# *Final Remedial Investigation Report*

*West Central Phoenix  
East Grand Avenue WQARF Site*

Volume III of III: Appendices E through K

Comparison of SRP Well Annual Pumpage and Observed TCE Concentrations

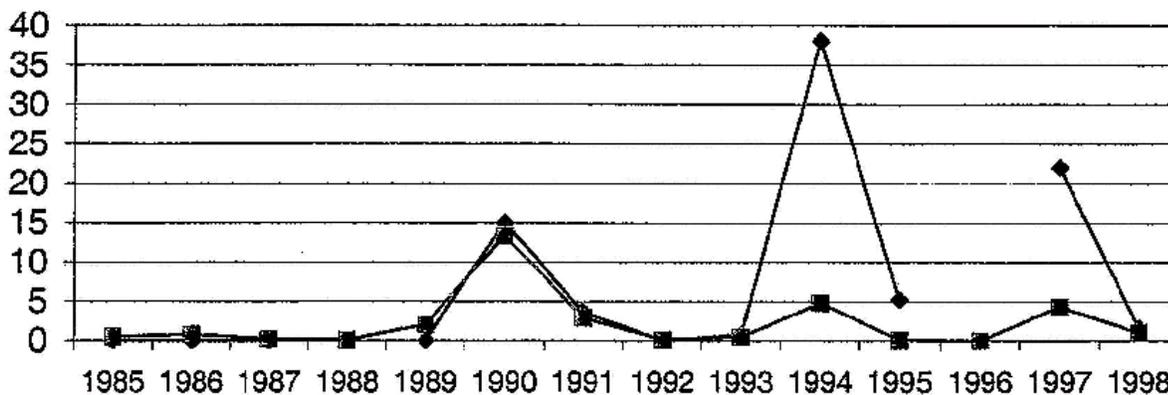
| Land & Water Use Report, Appendix D |        |  |   |
|-------------------------------------|--------|--|---|
| 2-6<br>2-7                          | 3<br>1 | What are the water quality criteria that water sources discharging to the SRP Grand Canal must meet? How do these criteria compare to the water quality found at SRP wells, 10.5E-7.5N and 11.2E-7.7N? | Discharges to the SRP Canal must be permitted through the Arizona Pollutant Discharge Elimination System (AZPDES) Program and approved by SRP. Water quality criteria vary depending on type of discharge received. |

Figure 1  
WCP EGA PCE Concentrations - January 2002

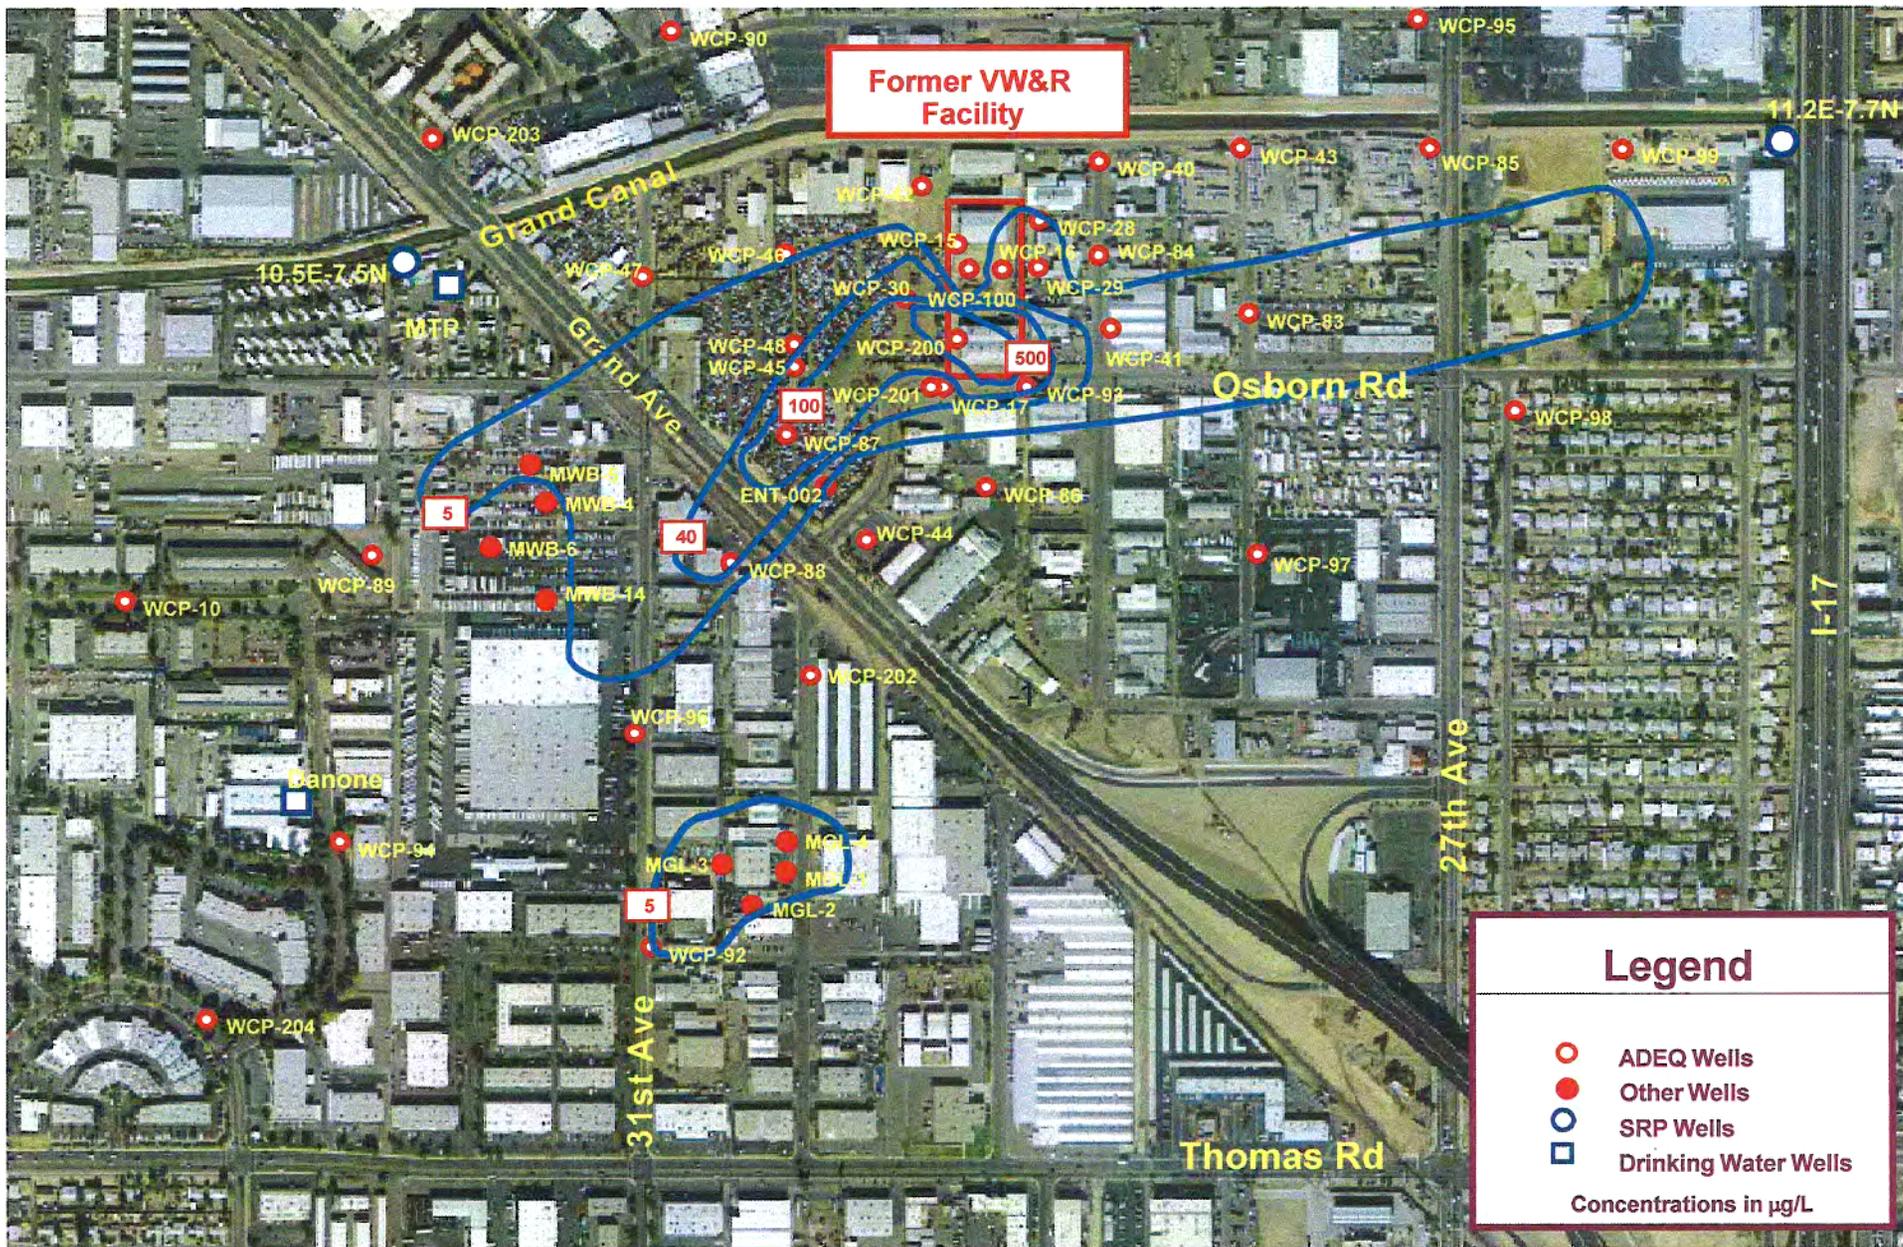
| Page # | Paragraph # | Comment  |
|--------|-------------|--|
| 5      | 2           | In addition to a source of VOCs at the former VW&R facility, there is an upgradient source of TCE as identified in Figure 2. The identity of the Responsible Party for this upgradient source of TCE is not known. What is ADEQ's process to determine responsibility if: <ul style="list-style-type: none"> <li>• The MTP drinking water well is lost in the future?</li> </ul> |

| West Central Phoenix, Proposed RO Report |             |   |   |
|--|-------------|---|---|
| 5<br>5<br>6                              | 2<br>5<br>2 | In addition to a source of VOCs at the former VW&R facility, there is an upgradient source of TCE as identified in Figure 2. The identity of the Responsible Party for this upgradient source of TCE is not known. What is ADEQ's process to determine responsibility if: <ul style="list-style-type: none"> <li>• The MTP drinking water well is lost in the future?</li> <li>• The Danone Waters drinking water well is lost in the future?</li> <li>• The SRP groundwater supply is threatened?</li> </ul> | <p><i>ADEQ has not been able to identify the source of TCE contamination upgradient to the VW&amp;R facility. The low concentrations of TCE in groundwater attributable to the upgradient source do not allow identification of the source area by examining the concentration gradient. Further, ADEQ could not identify any facilities in the area of the upgradient TCE plume that would have used TCE. ADEQ is not aware of any other reasonable or cost effective investigative technique that would identify the source area for the upgradient TCE contamination.</i></p> <p><i>Because remedial investigations have not located the source area for the upgradient TCE contamination, a responsible party search cannot be conducted to determine who might be liable for this contamination.</i></p> |
